ENGINE - FUEL AND CONTROL - ENGINE - FUEL SYSTEM TUBES - RESET FUEL RETURN TUBE -
DISCONNECT TO FUEL METERING UNIT - CATEGORY CODE 7 - MOD.ENG-73-0049

V2500-ENG-73-0049

Location of fuel return tube - Disconnect to F.M.U.
Fig.1

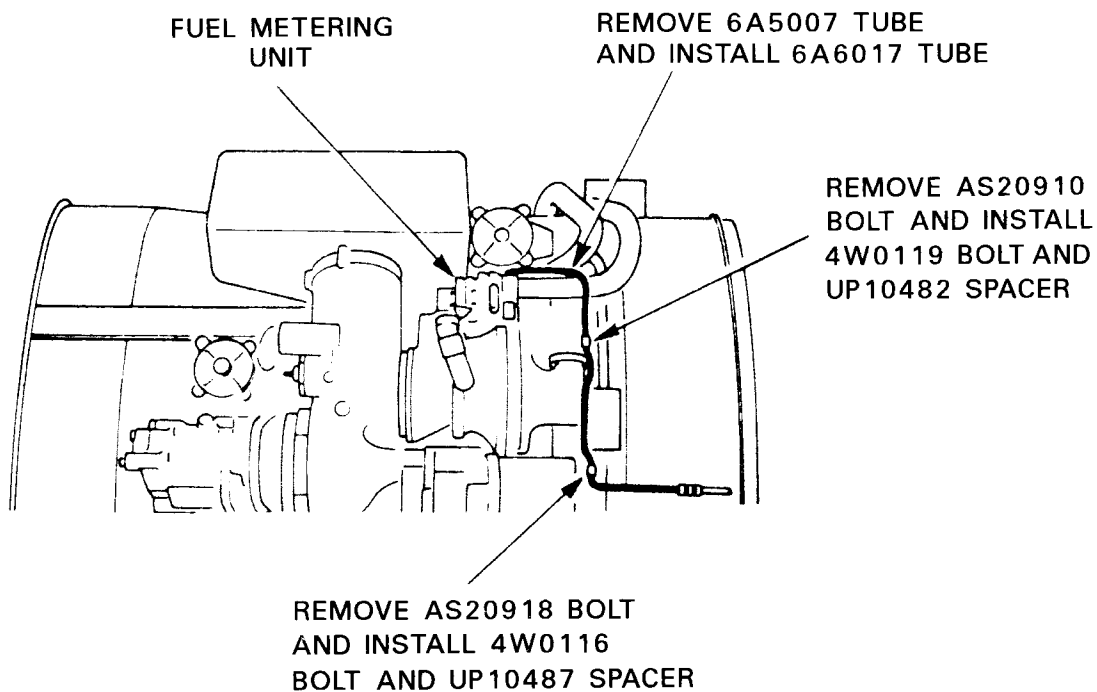
- (1) Find the 6A5007 fuel tube. Refer to Figure 1.

- (2) Put the container in position under the 6A5007 fuel tube.

- (3) Remove the three bolts that attach the 6A5007 tube to the FMU, cut the lockwire and disconnect the fuel tube connector.

View looking forward on H.S. gearbox - After alteration
Fig.2

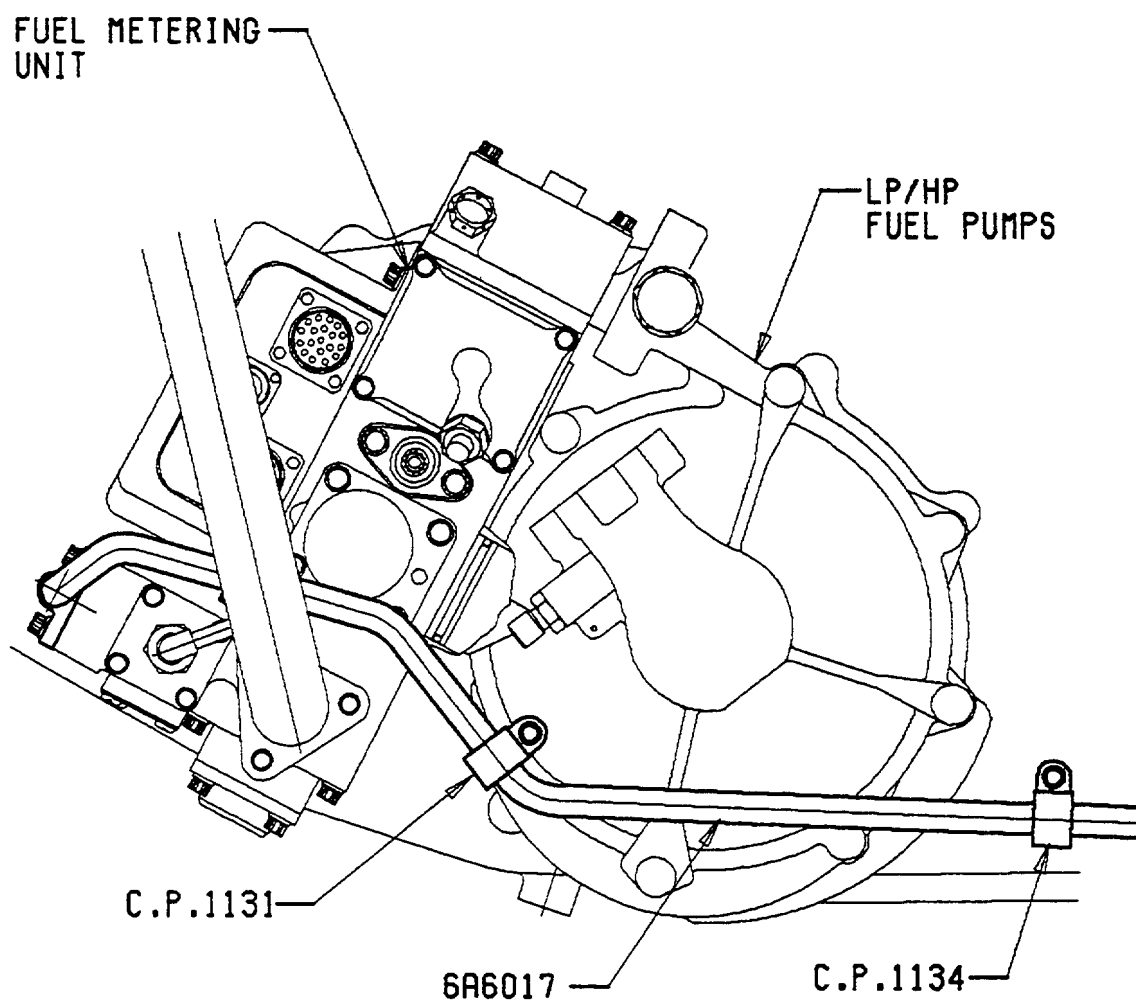
- (1) A new fuel return tube assembly having a revised run local to the L.P. fuel pump and F.M.U. is introduced.
- (2) Existing clipping points (CP1131 and CP1134 are modified by the addition of a spacer to accommodate the new tube run.

- (9) Install 6A6017 fuel tube. Refer to Figures 2, 3 and 4.

- (10) Lightly lubricate a new AS43013-112 packing with CoMat 10-038 petroleum jelly or CoMat 10-060 liquid paraffin. Install the packing on the 6A6017 fuel tube at the flange face location.

- (11) Attach the 6A6017 fuel tube to the FMU with the 4W0169 bolts (3 off).

- (12) Connect the 6A6017 tube connection.

- (13) Torque the three attaching bolts to 85 to 105 lbfin (10 to 12 Nm). Torque the tube connection to 283 to 310 lbfin (32 to 35 Nm). Safety connection with CoMat 02-126 lockwire.

Clipping point CP 1131
Fig.3

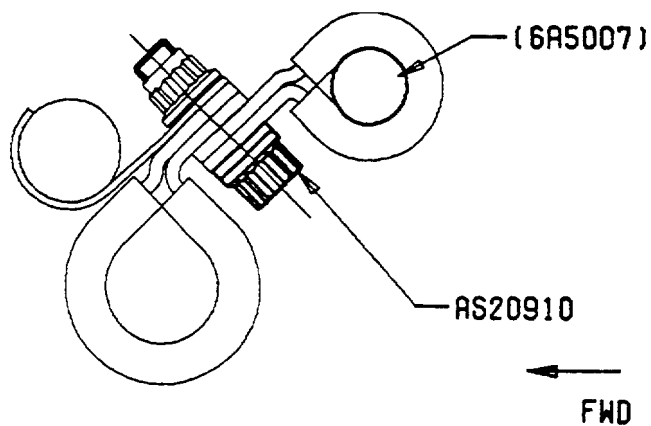
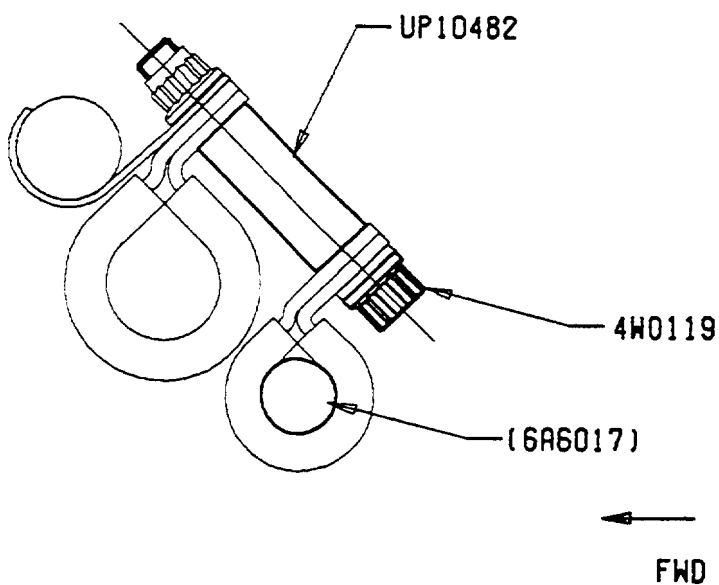
- (5) Remove the bolt, washer, clips and nut at clipping point CP 1131 sufficiently to allow removal of the 6A5007 fuel tube.

- (14) Install the 4W0119 bolt, washer, UP10482 spacer, clips and nut at clipping point CP1131.

(16) Torque the nut and bolt at clipping points CP 1131 and CP 1134 to 36 to 45 lbfin (4 to 5 Nm).

Clipping point CP 1134
Fig.4

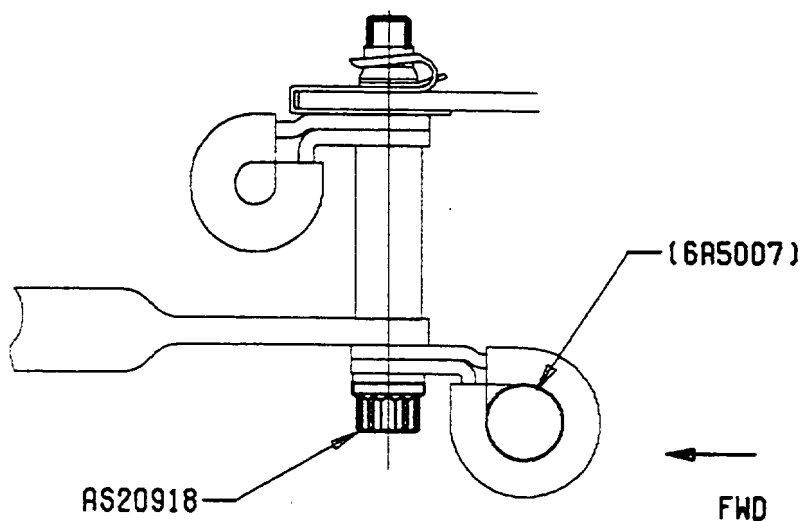
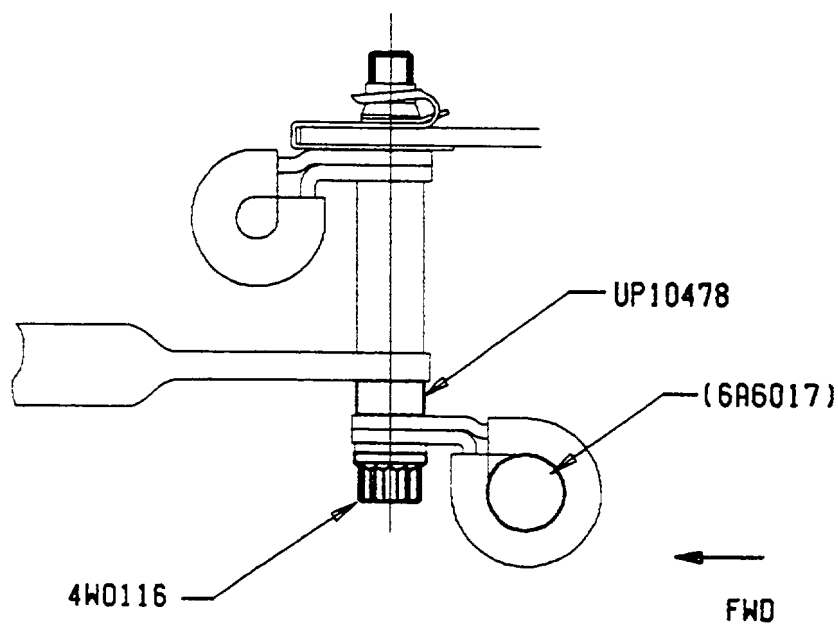
- (6) Remove the bolt, washer, clips and spacer at clipping point CP 1134 sufficiently to allow removal of the 6A5007 fuel tube.

(15) Install the 4W0116 bolt, washer, clip, UP10478 spacer, spacer and clip at clipping point CP 1134.
